JOINT REGIONAL PLANNING PANEL (East)

JRPP No	2015SYE162
DA Number	443/14/2
Local Government Area	North Sydney Council
Proposed Development	Section 96(2) application to modify consent for reconfiguration of podium levels and new hotel tower: Alterations and additions to podium to include supermarket, retail and food premises with new hotel
Street Address	100 Miller Street North Sydney
Applicant/Owner	Cromwell Seven Hills Pty Ltd
Number of Submissions	One
Regional Development Criteria (Schedule 4A of the Act)	Section 96(2) Modification application of Capital Investment Value > \$20M
List of All Relevant s79C(1)(a) Matters	North Sydney LEP 2013 - Zoning – B3 Commercial Core North Sydney DCP 2013 S94 Contribution Railway Infrastructure Contribution SEPP 55 - Contaminated Lands SREP (2005)
List all documents submitted with this report for the panel's consideration	Plans
Recommendation	Approval
Report by	Geoff Mossemeneer, Executive Planner, North Sydney Council

Assessment Report and Recommendation

Figure 1 – Old/New Shard corner profile diagram
Source: Rice Daubney

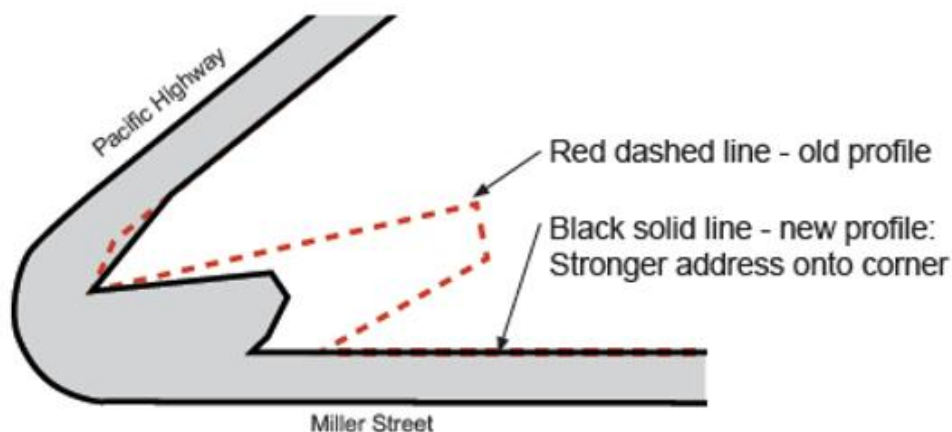
It is proposed to reduce the depth of opening into the shard entry to strengthen the street edge as shown in Figure 1. This responds more favourably to comments raised previously through the DEP review in relation to the reinforcement of the street corner and its relationship with the public domain.

The amended design provides for a more usable space that is protected from adverse weather events and consists of a firmly expressed entrance. This provides an appropriate balance between the original design intent of the southern corner and the concerns expressed by the DEP of the space potentially becoming a bleak and uninviting gap.

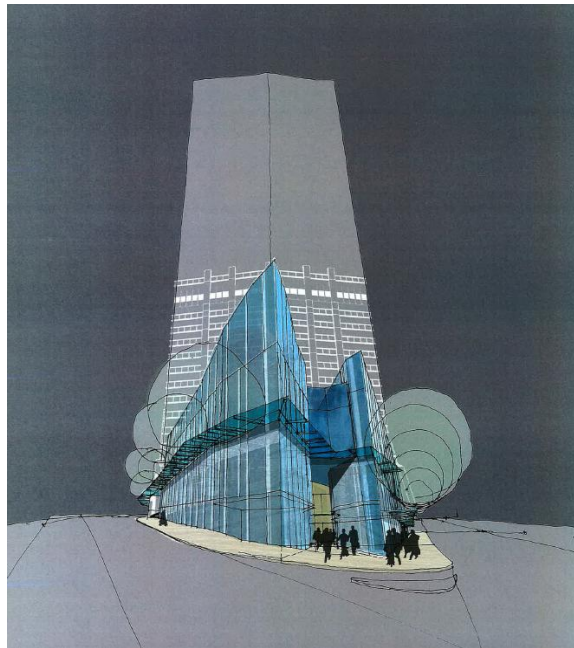
This awning does not satisfy condition B3 in that there is no canopy over the entrance and there is no awning over the public footpath at the entrance. The proposed awning does not address the concerns from the DEP with the cover and shelter provided at the corner of the site and the height of the awning at the corner that is significantly higher than the Miller Street awning. Council's Development Control Plan also calls for a street awning in such circumstances. The corner is south facing and the awning will not

provide adequate shelter as proposed and clearly reduces the standard of protection below that provided by the existing awning.

Rice Daubney sketch of corner treatment

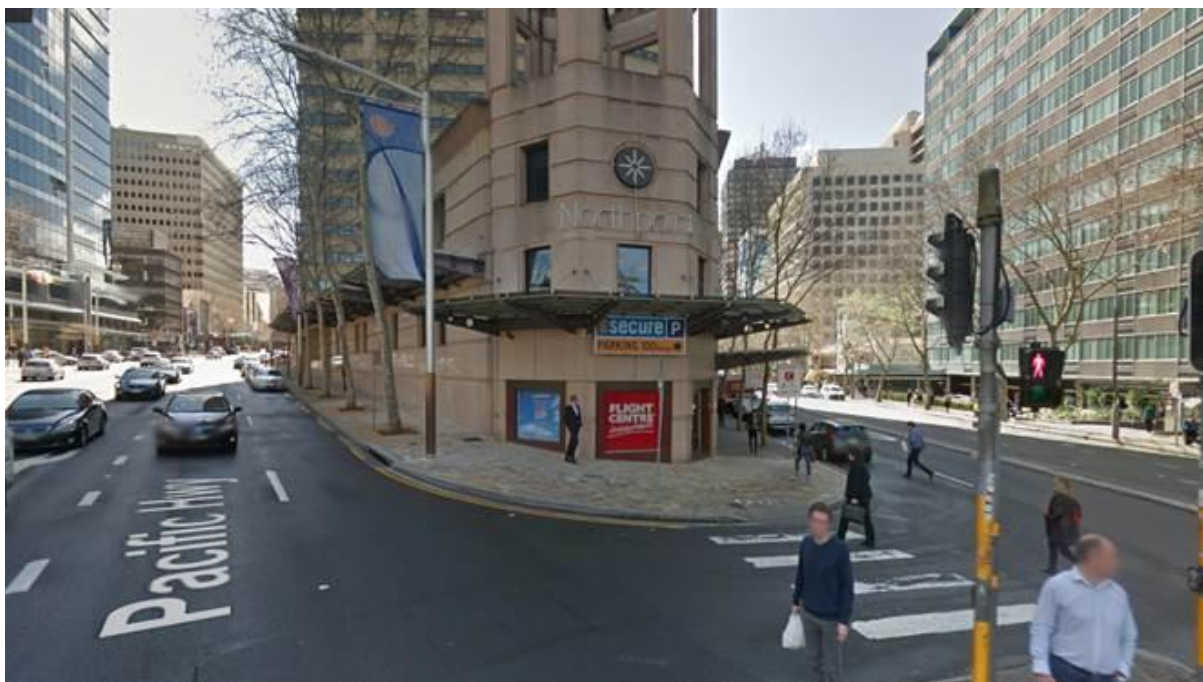
The only item that is at issue is the awning at the corner of the site. The DEP comments have not been satisfactorily addressed in your statement or on the plans. The awning is too high and inadequate. The preferred solution is to have the awning around the corner no higher than half way between the Pacific Highway awning and the Miller Street awning with overlaps for weather protection in a similar manner to the existing awning.

The awning shall follow the street boundary to provide a consistent width over the public footpath. The height of any roof over the entrance behind the street awning can either be at the same height of the awning or the height of the soffit (FL level 9?).

The plan of the corner does not show sufficient detail. Please provide a larger scale drawing of the corner showing your proposed finished levels and footpath levels.

Amended plans for the corner awning would be appreciated or your further submission including a perspective of the proposed awning addressing how it meets the DEP concerns.

In response to the query of having an awning midway between Level 8 and 9 we note the following: The fixing of an awning to the façade between Levels 8 and 9 would result in altering the seamless curtain wall façade, introduce additional spandrels and alter the glass panel break-up.

This change would also result in the Café tenancies at Level 8 having an awning midway through their façade line and therefore the view out of the café is struck at the awning line whilst sitting at the window or standing in the tenancy. Our selling point for these retail tenancies is the seamless view onto the five way intersection. We see this as a major compromise to the retail space and may also affect the ability to lease these spaces as we see them as the premium retail location in the development.

To provide support to the awning we would need to introduce vertical structure in the form of steel posts or similar at each outrigger location (approx. 1800mm c/c) to carry the awning reactions. This would then have a significant impact on the architecture of the façade. Another option would be to provide a large horizontal transom between the existing primary columns to support the outriggers however this again would have a significant impact on the architecture and design intent of the façade at this entry point.

- B3. The required street awning to the Pacific Highway shall be continued around the southern corner of the site (intersection of Pacific Highway and Miller Street) **no higher than half way between the Pacific Highway awning and the Miller Street awning with overlaps for weather protection. The awning shall follow the street boundary to provide a consistent width over the public footpath. The height of any roof over the entrance behind the street awning can either be at the same height of the awning or the height of the soffit (FL level 9).**
